RE: North Florida-Southeast Georgia (NFSEG) Regional Groundwater Flow Model

Review Questions and Comments

Appendix A
Initial Review Questions and Comments
Liquid Solutions Group, LLC
May 27, 2016

Appendix B
Preliminary Review Questions, Comments and Responses
Liquid Solutions Group, LLC
October 2015 to January 2016

Figure 15 – Hydrologic Boundary Conditions set for the Lower Santa Fe River

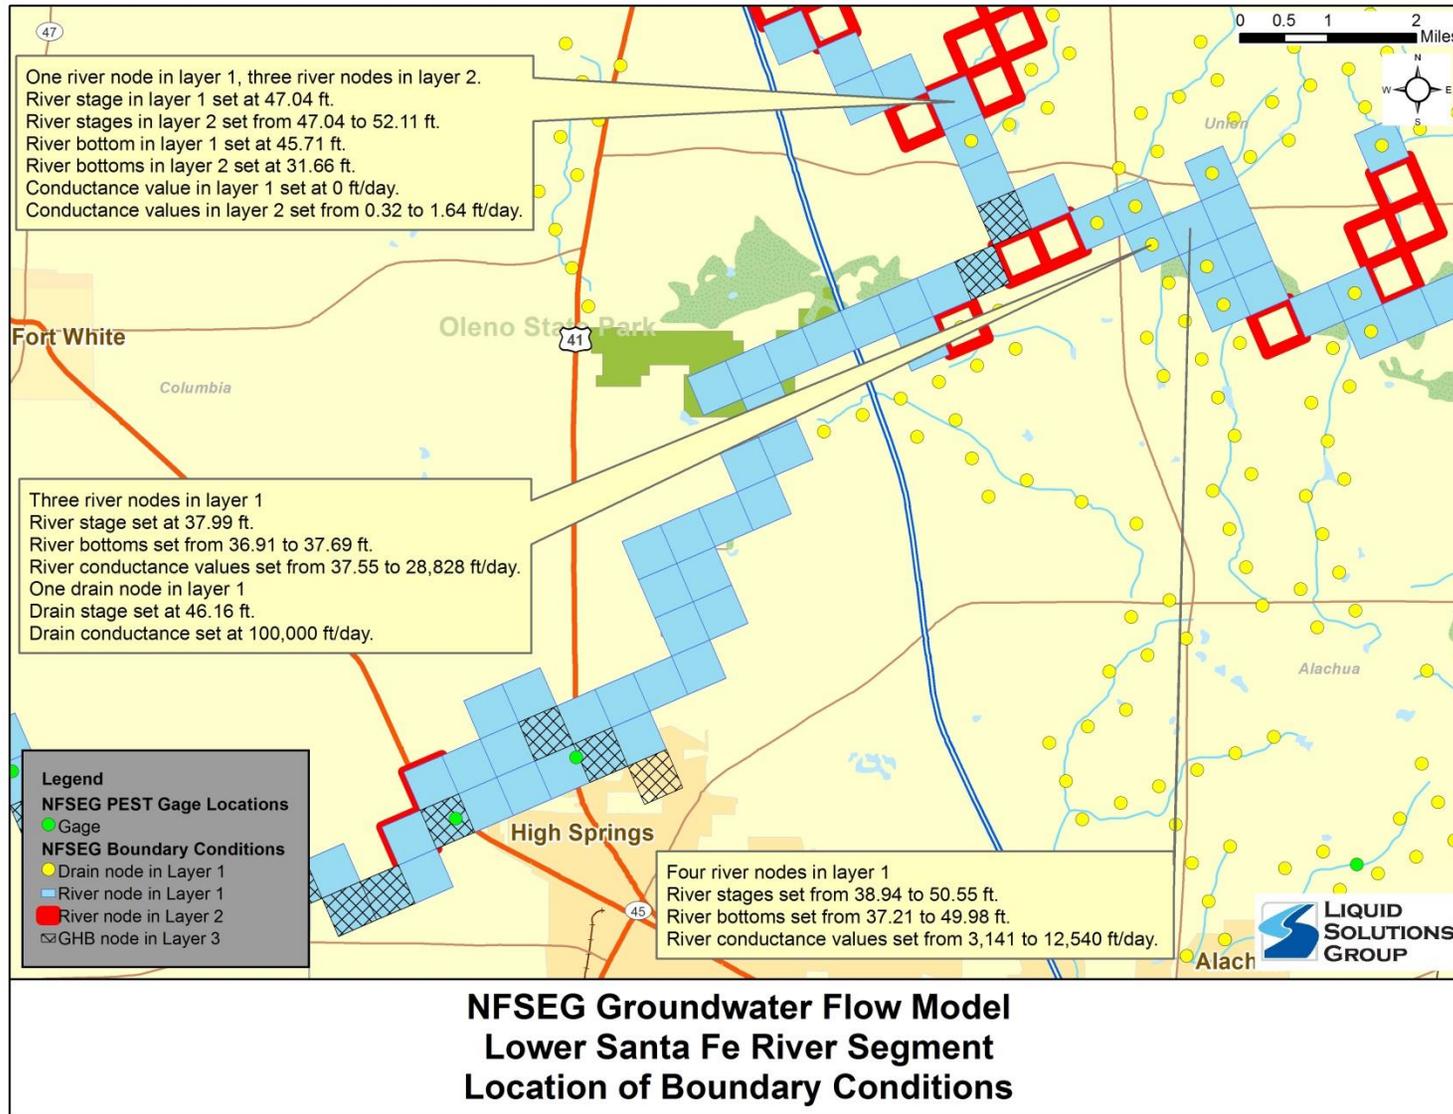
Figure 15 attached presents a segment of the Santa Fe River basin that demonstrates some of the potential issues that have been identified. Using this figure as an example, LSG has the following questions regarding the hydrologic boundary conditions used in the model:

- Along the Santa Fe River, there are often overlapping boundary conditions that appear to be conflicting with one another. **Figure 15** presents three examples. The northernmost example has four River Nodes in one cell; one in Layer 1 and three in Layer 2. The stages set in the River Nodes vary from 47.04 feet to 52.11 feet. The

river bottom elevations set in these River Nodes vary from 31.66 feet to 45.71 feet. Riverbed conductance values set in these River Nodes range from 0 feet/day to 1.64 feet/day. Based on this information, we have the following questions:

Figure 16 – Hydrologic Boundary Conditions set for the Suwannee River

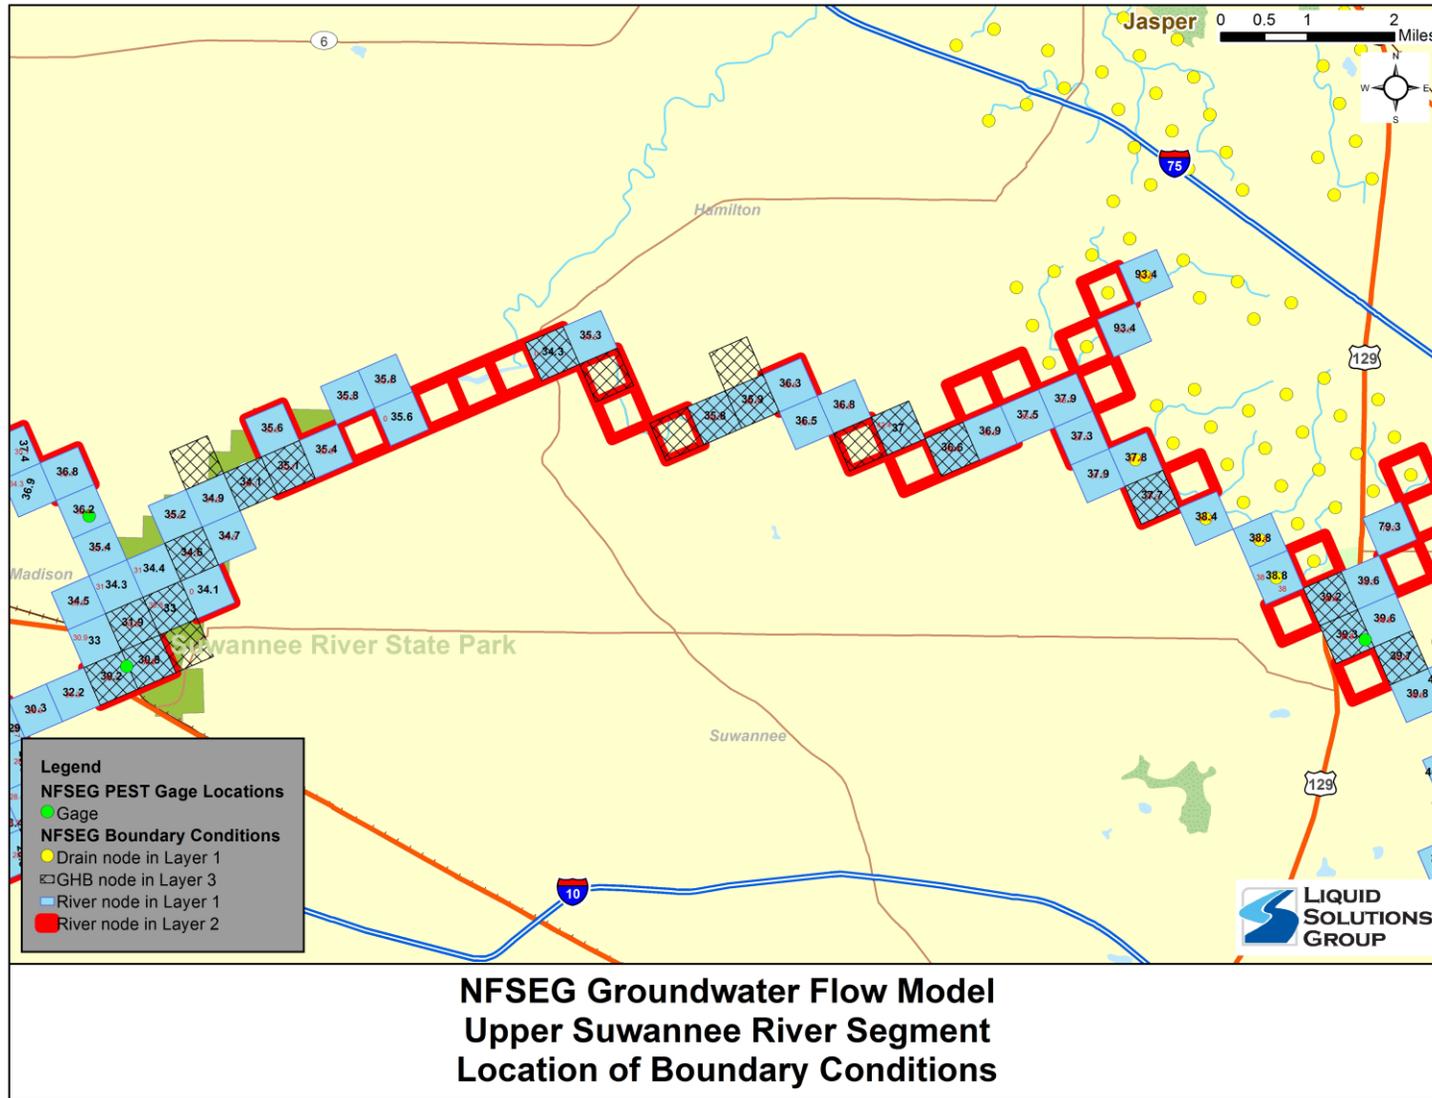
Figure 16 presents a segment of the Upper Suwannee River as represented in the NFSEG groundwater flow model. Using this figure as a second example, LSG has the following questions and comments regarding the hydrologic boundary conditions used in the model:

- There are segments of the Suwannee River with Layer 2 River Nodes, but no Layer 1 River Nodes. Why are the Layer 1 River Nodes discontinuous in this (and other) locations? What does this conceptualization represent? What process was used to define the assignment of rivers to the hydrostratigraphic layers represented in the groundwater flow model?
- In **Figure 16**, the assigned Layer 1 River Node stage and simulated Layer 1 heads have been added in red and black text, respectively.
- “Humps” in the assigned stages can be observed along the Suwannee River.
- There are Layer 1 River Node stages set to 0 feet.
- There are multiple cells with overlapping hydrologic boundary conditions.

Figure 17 – Hydrologic Boundary Conditions set for the Suwannee River 2

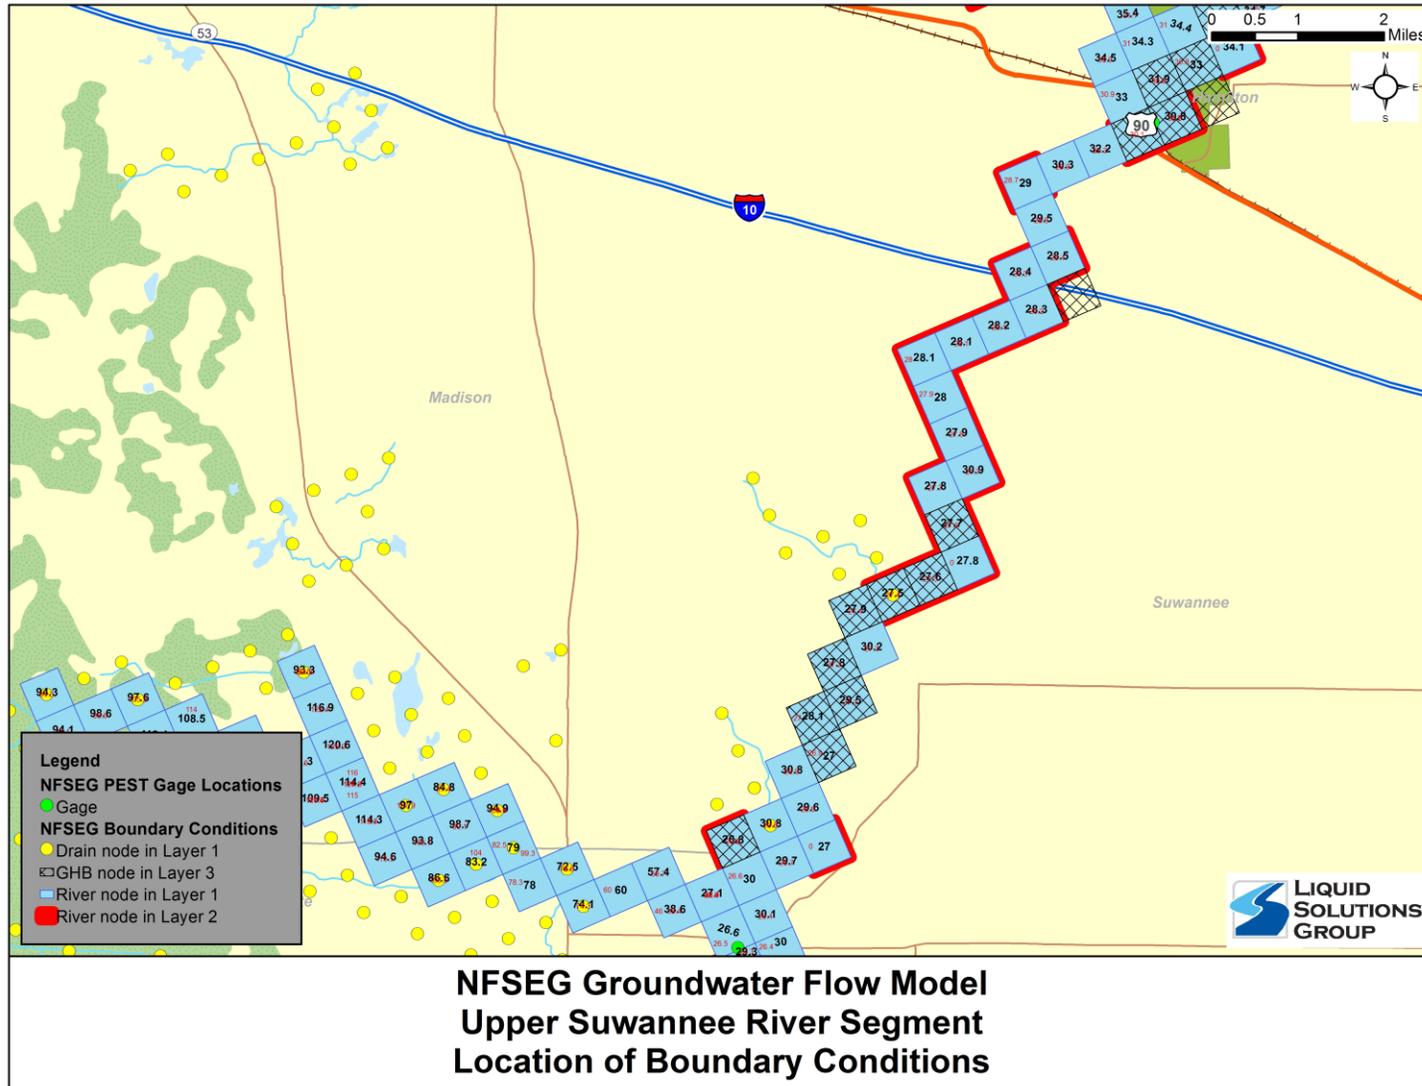
Figure 17 presents a segment of the Upper Suwannee River, just downstream of the segment presented in **Figure 16**, as represented in the NFSEG groundwater flow model. Using this figure as an example, LSG has the following questions and comments regarding the hydrologic boundary conditions used in the model:

- There are Layer 1 River Node stages (presented in red text) that are set to 0 feet.
- Though we understand the groundwater head in Layer 1 (presented in black text) is not necessarily going to converge to the assigned stage of the Layer 1 River Node, we would expect the calibrated heads and assigned stages to be reasonably close, particularly if the assigned stages were based on historical data. There are cells presented in **Figure 17** where the calculated head in Layer 1 is over 20 feet different than the assigned stage of the Layer 1 River Node. Please explain why the Layer 1 calculated heads are sometimes notably different than the assigned stages of the Layer 1 River Nodes.
- There are multiple cells with overlapping hydrologic boundary conditions.

Figure A7 – 2009 MODFLOW Calibration Results

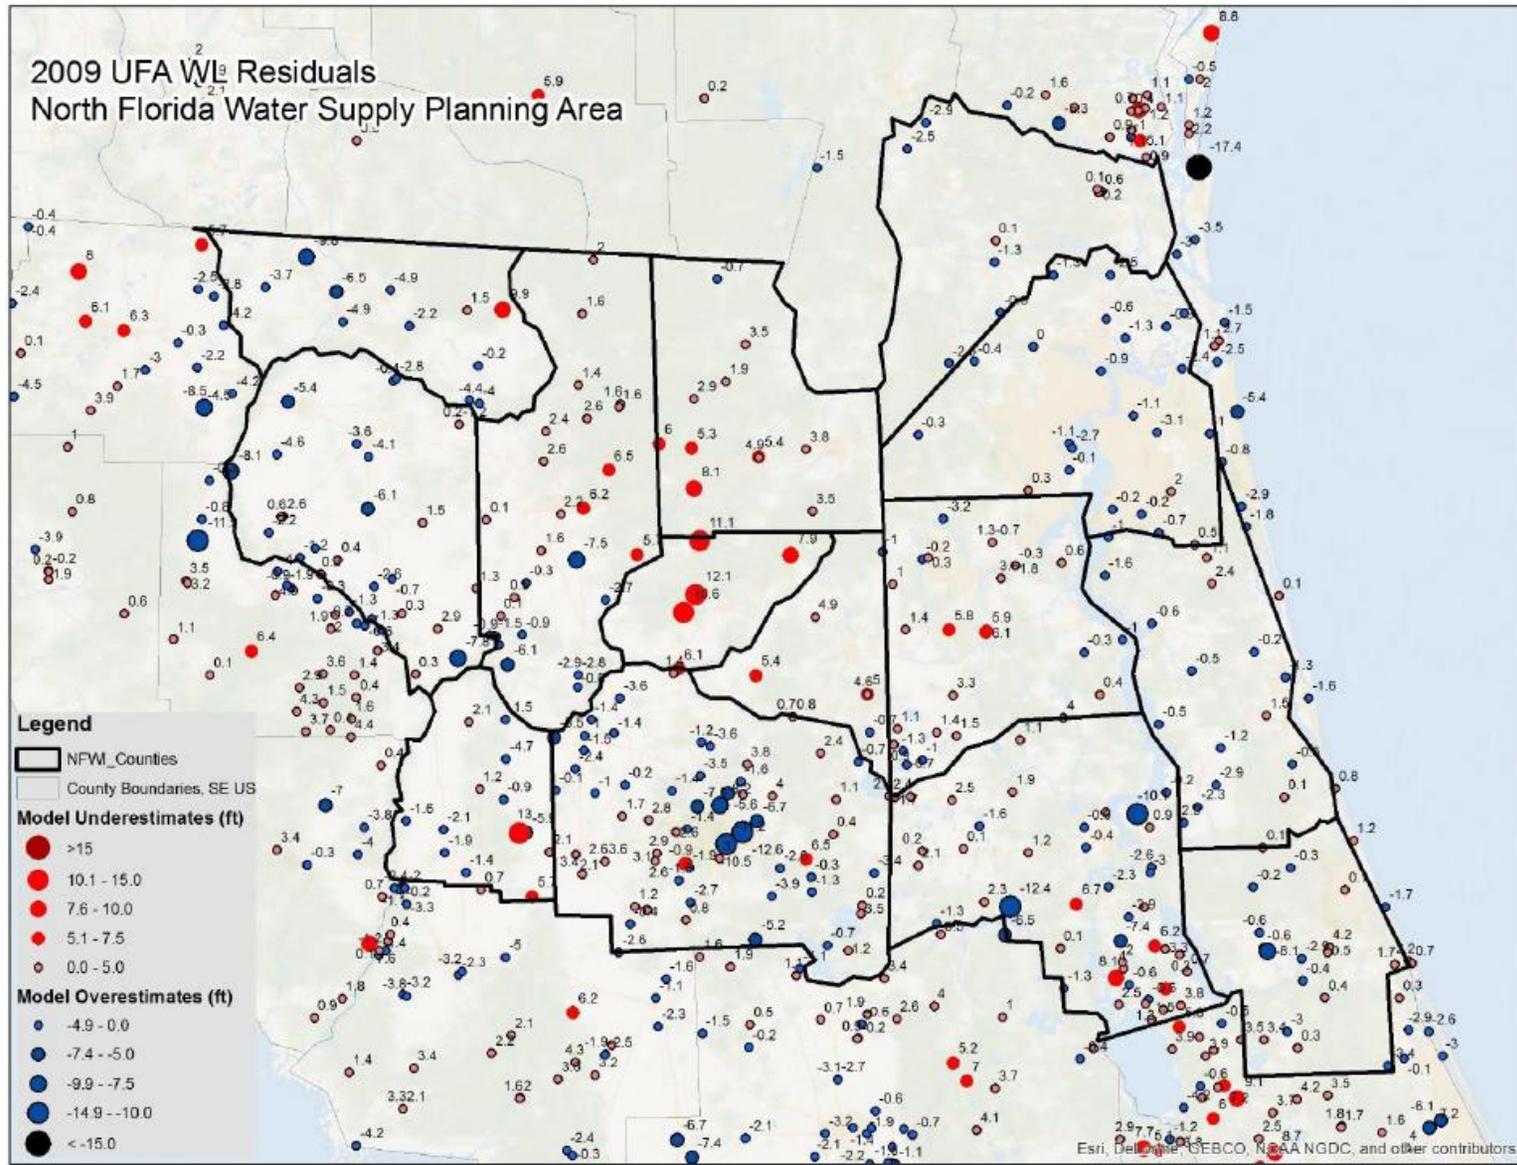
- A13) The NFSEG MODFLOW model has several areas in the NFRWSP region that appear to uniformly (or almost uniformly) overpredict or underpredict the UFA potentiometric surface by more than average. As shown in **Figure A7**, we note areas in Union, Bradford, Baker, Columbia and Clay Counties, and Putnam and Volusia Counties as having underpredicted potentiometric levels. While an area in Alachua County has overpredicted potentiometric levels. We would request that the Districts further evaluate these areas to improve the calibration.

Figure A10 – 2001 MODFLOW Net Recharge near Union County

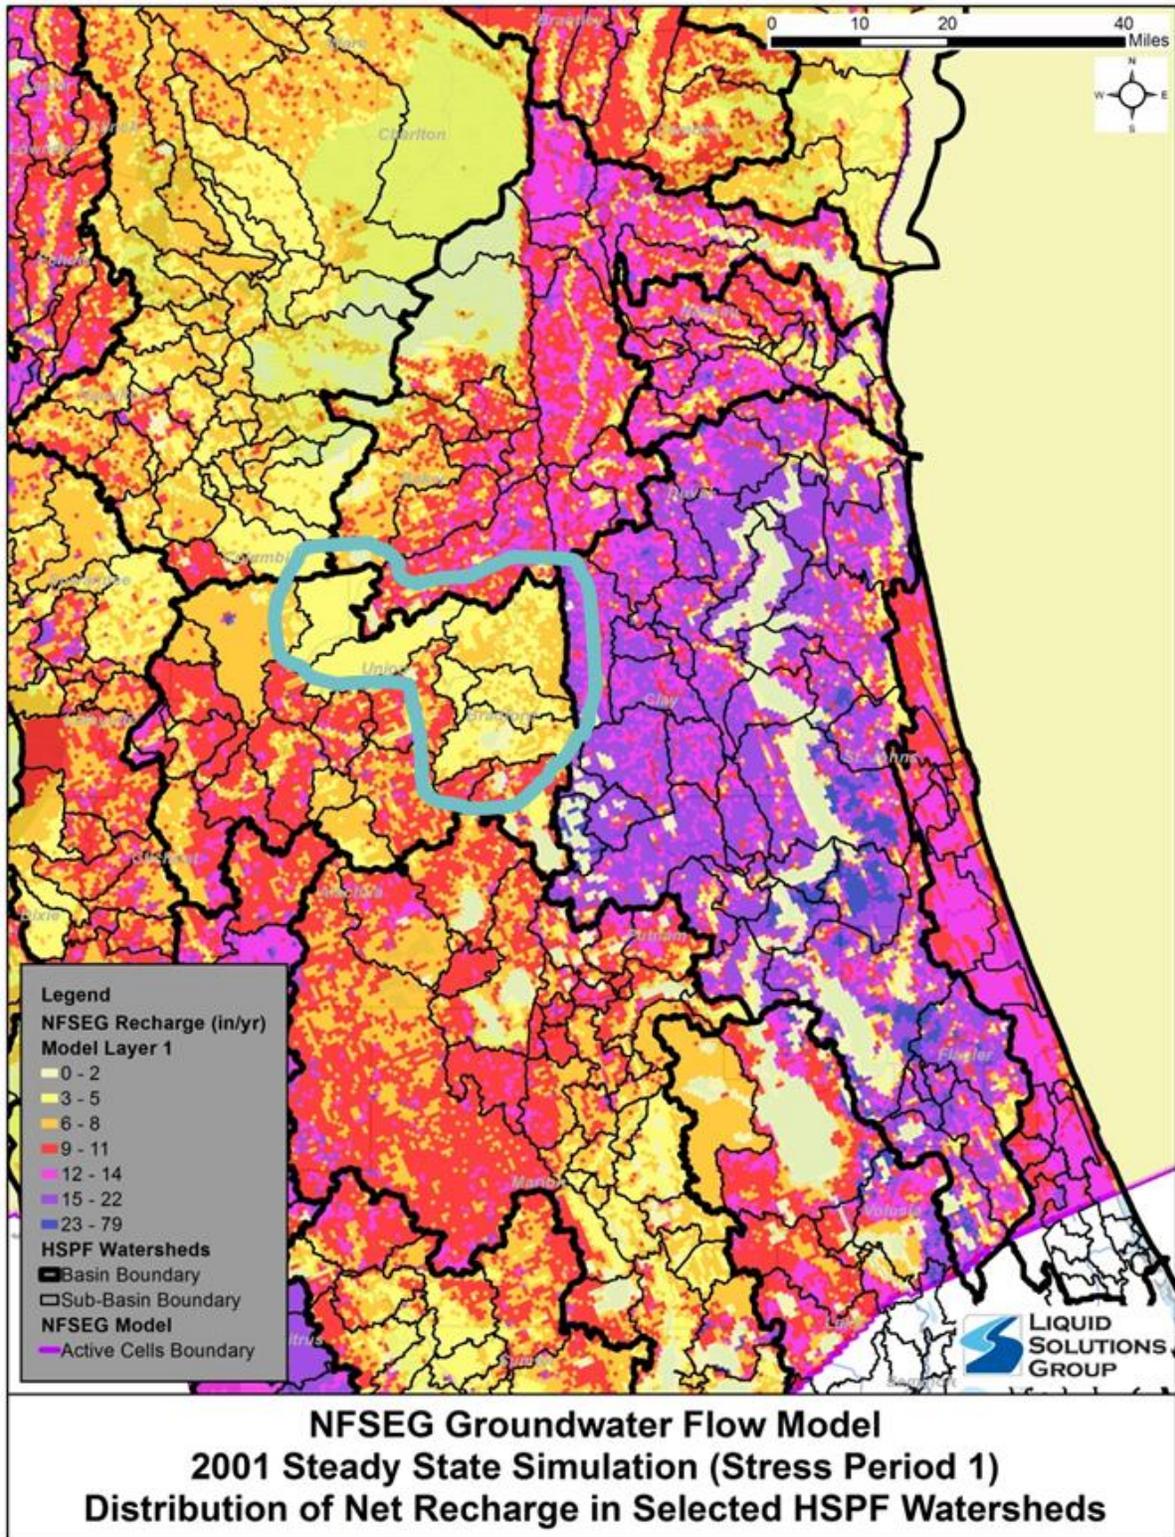
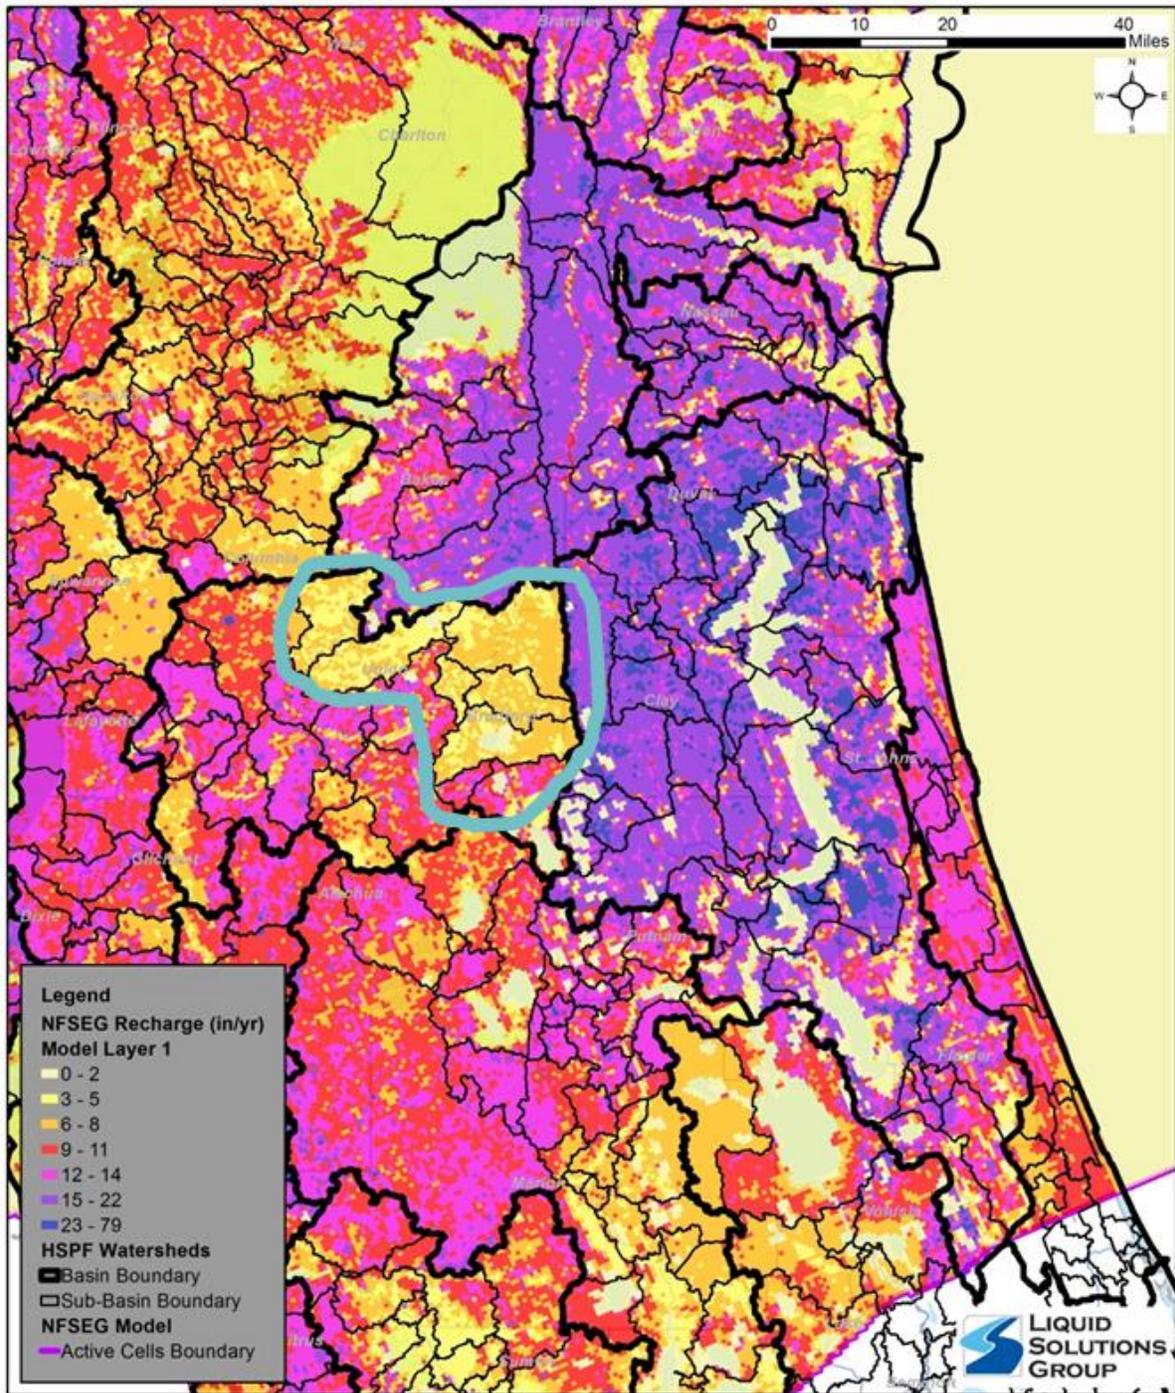
- A17) Recharge to MODFLOW is derived as an output from the HSPF models. In our review of MODFLOW recharge input, significant discontinuities in recharge occur in some locations along HSPF model boundaries. As shown in **Figure A10** and **Figure A11**, one such area is in Union and Bradford Counties where the Lower St. Johns River, St. Mary's River and Santa Fe River HSPF models converge. Please explain the differences in MODFLOW recharge in this area.
